**BOARD OF ZONING ADJUSTMENT
STAFF REPORT****Date: March 2, 2015****CASE NUMBER**

5953

LOCATION103 North Warren Street
(Northwest corner of North Warren Street and St. Michael Street)**VARIANCE REQUEST****BULK SITE:** Bulk Site Variances to allow a wooden surfaced terrace to occupy 26% of the primary frontage on North Warren Street, a 12" high terrace for outdoor seating, and allow a metal canopy in the Downtown Development District.**ZONING ORDINANCE
REQUIREMENT****BULK SITE:** The Zoning Ordinance requires a terrace to occupy 100% of the building façade except where driveways are permitted, terraces must be paved or landscaped with a minimum of 20" high terrace for outdoor seating, and does not allow metal canopies in the Downtown Development District.**ZONING**

SITE PLAN

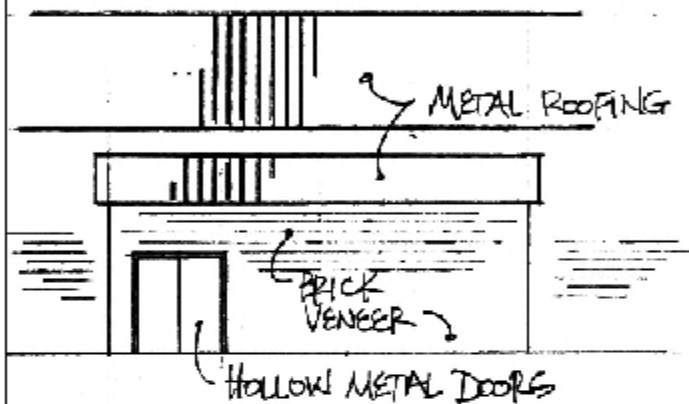
The Zoning Ordinance allows for a site within the Downtown Development District to have one curb-cut per street frontage. It should be noted that the proposed site plan illustrates an existing gravel driveway along North Warren Street, a proposed gravel driveway for grain delivery along St. Michael Street, and an existing concrete drive entrance along St. Michael Street. The existing

concrete drive along St. Michael should be removed, and replaced with landscaping and curbing, or a new variance application should be submitted.

The primary entrance of a structure in the Downtown Development District shall be through the façade, parallel to the primary frontage. The applicant has identified North Warren Street as the intended primary frontage, therefore it should be noted that one of the two illustrated doors along North Warren Street shall be the primary entrance to the structure.

A site developed with a terrace frontage, such as proposed by the applicant, requires a raised terrace between 20 and 36 inches above sidewalk grade to occupy 100% of the width of the façade at the primary frontage (except where driveways are permitted), and shall be paved or landscaped. The proposed site plan illustrates a 12" high terrace that will occupy 24.5% of the width of the faced at the primary frontage. The applicant mentions that a terrace constructed to the required minimum height would require a long ramp that would not fit on the subject site, however, there is no mention of a ramp being required on the outside of the structure to access the terrace. Furthermore, there is no justification provided as to why a terrace is not proposed along the entire façade, except for the driveway, as required, nor why a paved or landscaped terrace is not an acceptable option.

The proposed site plan illustrates a proposed metal canopy over the proposed terrace, extending 13' along the façade of the structure (38% overall). A site with a terrace frontage is not required to have an awning; however, should the applicant wish to have an awning, it must be fabric, not extend beyond the terrace, and shall span a minimum of 80% of the frontage. The applicant states that a fabric awning of the proposed size "could not reasonably" meet building code standards for windloads, however no supporting evidence is provided. While that may be true, the applicant could use several smaller awnings which would be able to meet all building code requirements. It should be noted all awnings require a minimum clearance of 8' above the terrace level.

There are several pieces of information missing, which makes it difficult for staff to determine if the site will fully comply with the Zoning Ordinance in the Downtown Development District. No information is provided by the applicant regarding how waste will be handled. If a dumpster is proposed for the site, a revised site plan illustrating a dumpster in compliance with Section 64-3.I.12. of the Zoning Ordinance will be necessary. Also not illustrated on the site plan, is the location of the proposed HVAC system, electric meters, gas meters, and water meters, which are to not to be located along any frontage. There is also no mention of what material the proposed exterior façade will consist of, nor the proposed roof slope of the existing building, the proposed addition, or the proposed metal awning.

PROPOSED ADDITION ELEVATION
103 N. WARREN ST., MOBILE, AL
BOARD OF ZONING ADJUSTMENT
SCALE: 1" = 10' APRIL, 2015
DON WILLIAMS DEVELOPMENT

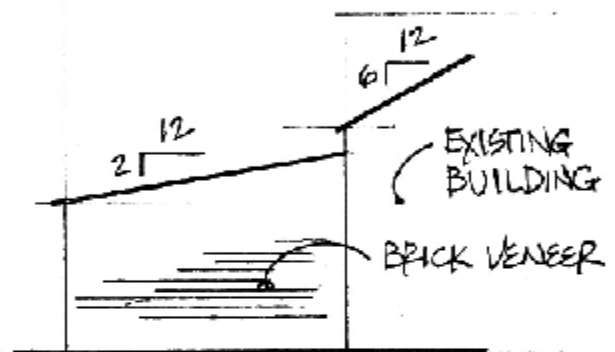
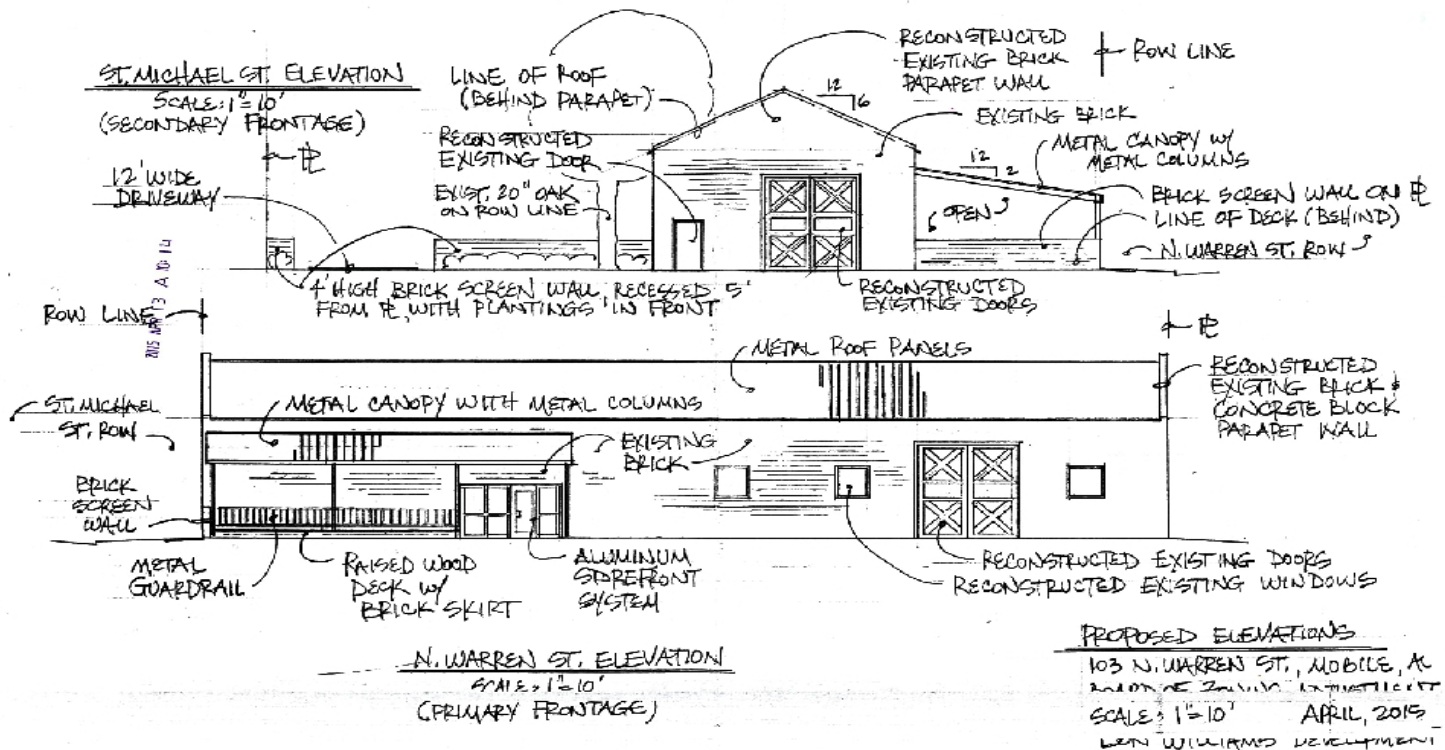
The applicant reviewed the various frontage options allowed in the Downtown Development District, and determined that the terrace frontage would be the most compatible with the existing structure. Elevation sketches were submitted to illustrate what the building will look like upon completion of the proposed project.

The Downtown Development District does not make any exceptions for existing structures being altered to fully comply with frontage design requirements, nor does it mention any allowances

for decks at this time. In order to comply with the frontage requirements of the DDD, the building would have to undergo a much more large-scale rehabilitation, including raising the existing structure a minimum of 16" above grade, which may be unrealistic to require.
